SKETCH OF PROPOSED DRIVEWAY WITH COST ESTIMATE

APPLICATION FOR DRIVEWAY CUTS AND OPENINGS

CITY OF CAMBRIDGE

Gilmore Street (BACK OF 250-252 WESTERN AVENUE.)

DRAWING 1:

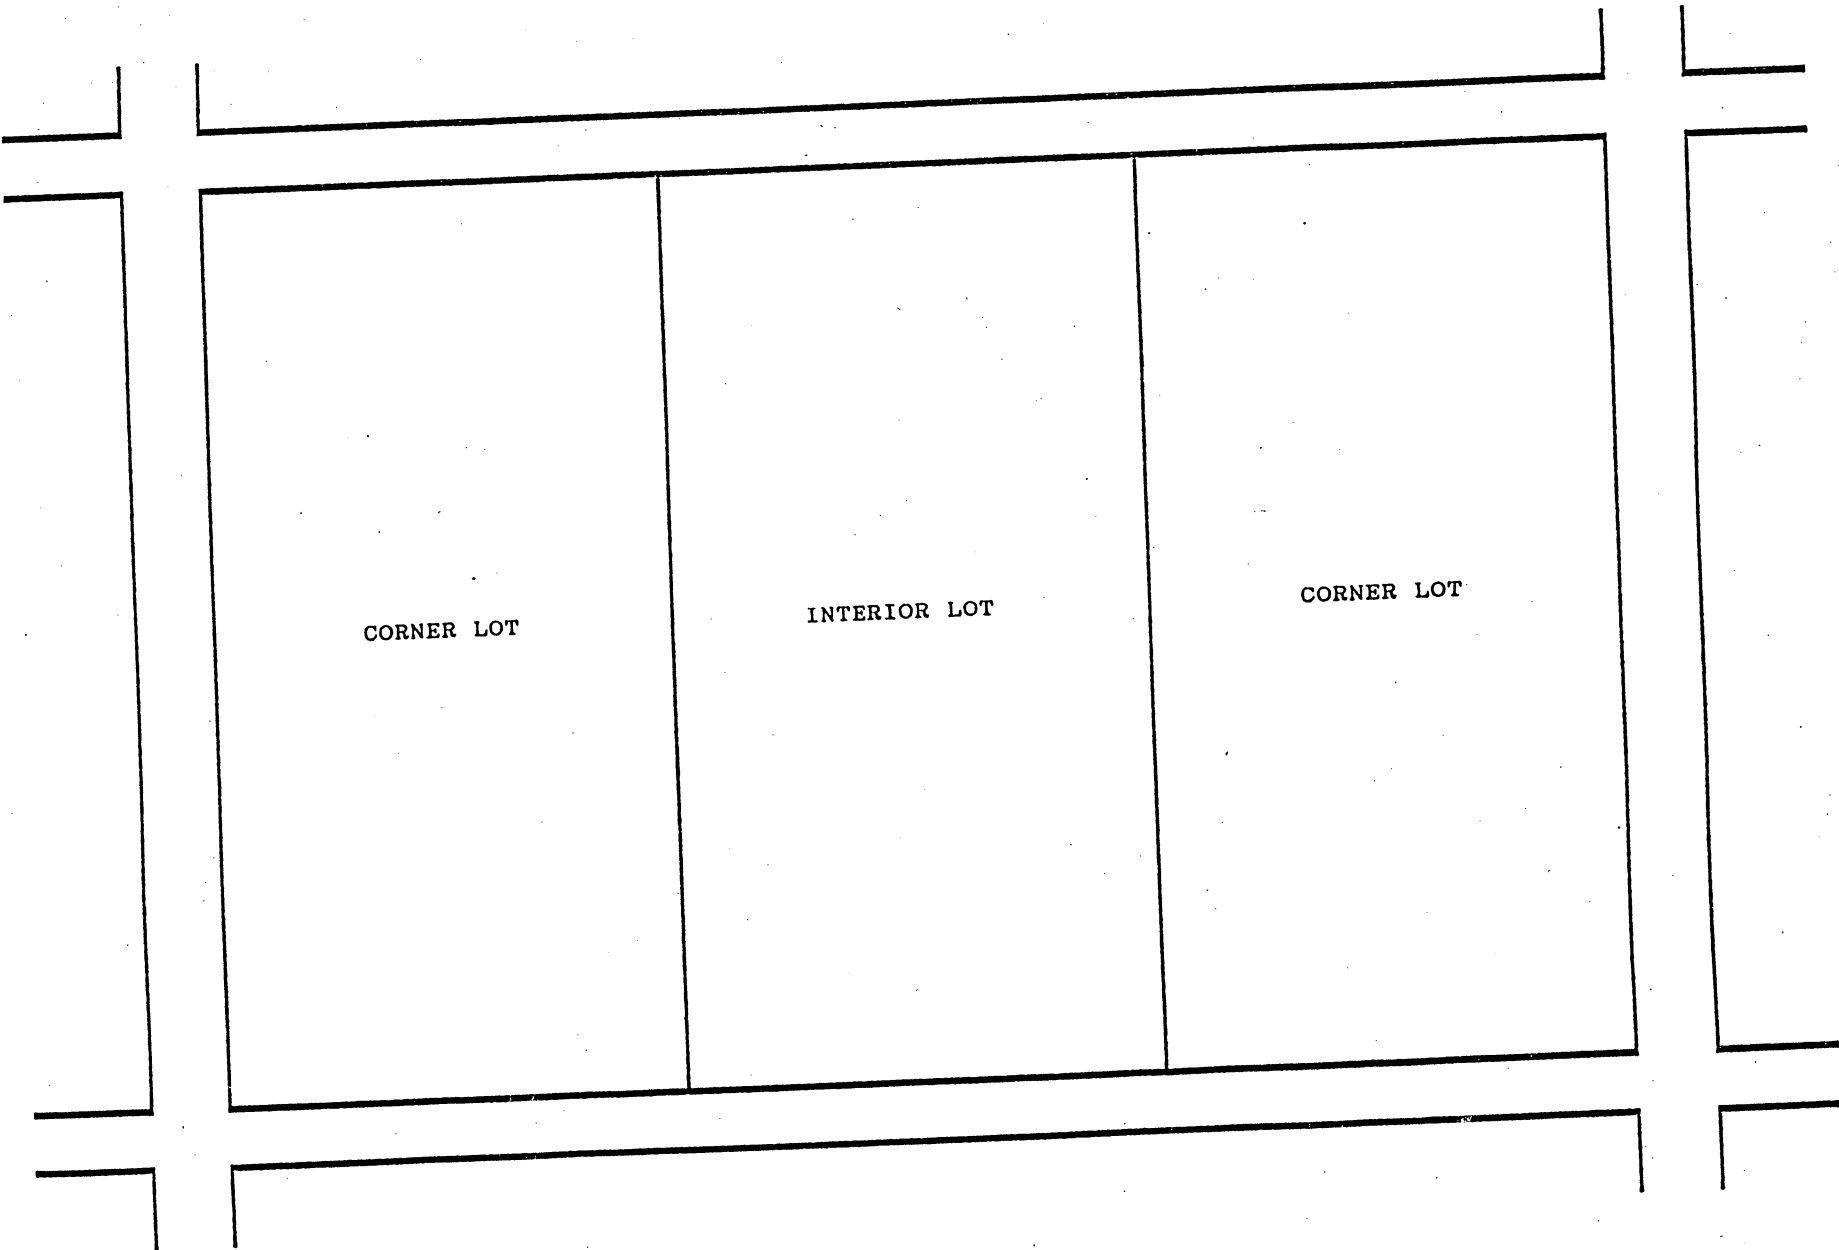
Reason: Violates front yard parking Art 6, Section 6.44(c) and required open space is removed article 5, Part 5.31 (15%)
